SHEET SIZE= C	DRAWN BY: F.S.B.	PART NUMBER or STYLE:	
SCALE = 1":1"	DATE DRAWN: 2/11/2015	C10 8ft Stair Section	
STANDARD TOLERANCE: .00 ±.01 FRACTIONS: .000 ±.005 ±1/16 ANG. ±.5°	LOC: Z:\Aluminum\Westbury\C10 Tuscany\Section\Stair	Quote requested by:	
FIRST USED ON:	DRAFT: 20141001-6F	PART NAME: C10 Tuscany	SHEET OF / REV. B

DSI Digger Specialties, Inc.
3446 US 6 EAST
Bremen, IN 46506

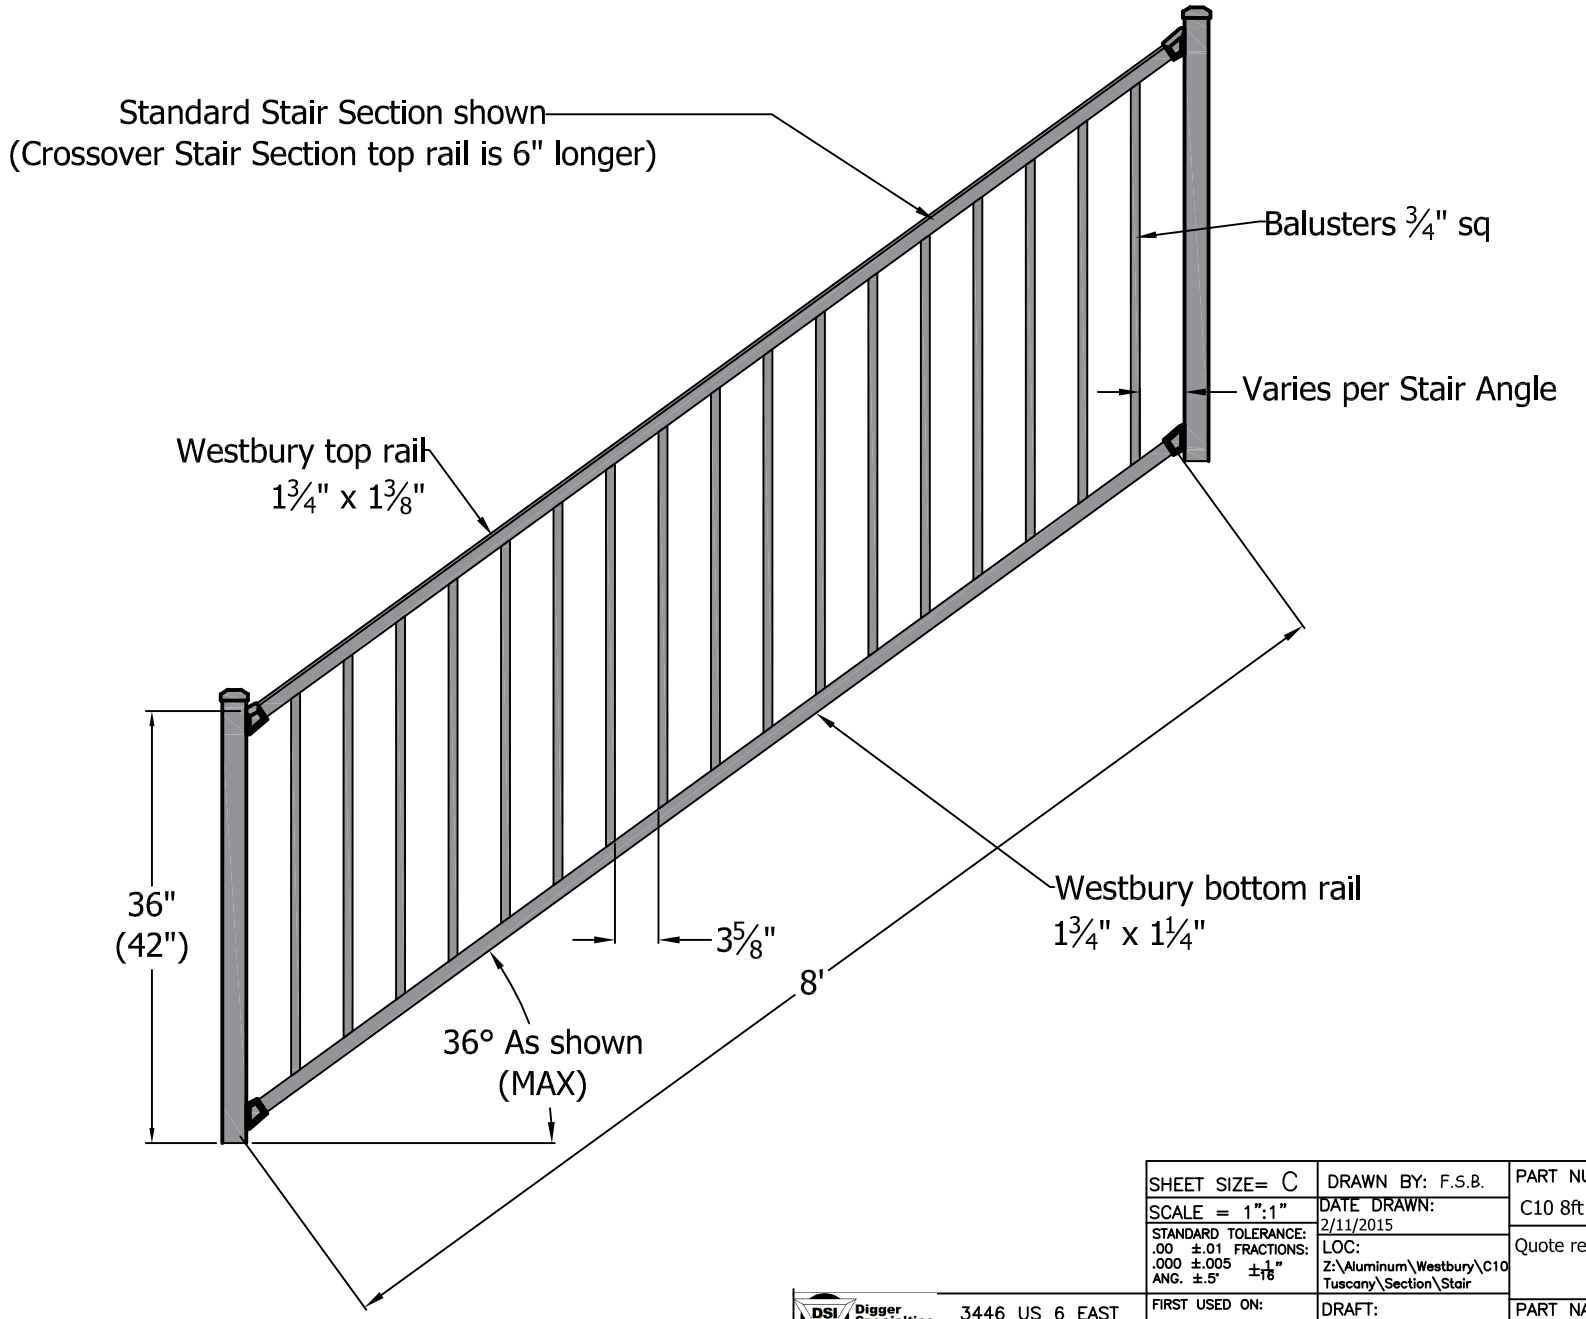
REV.	LOC.	REVISION	DATE
A		RELEASE PENDING APPROVAL	
B		Baluster spacing 3.625. Increased hole size to accomodate 36° stairs.	2/12/15
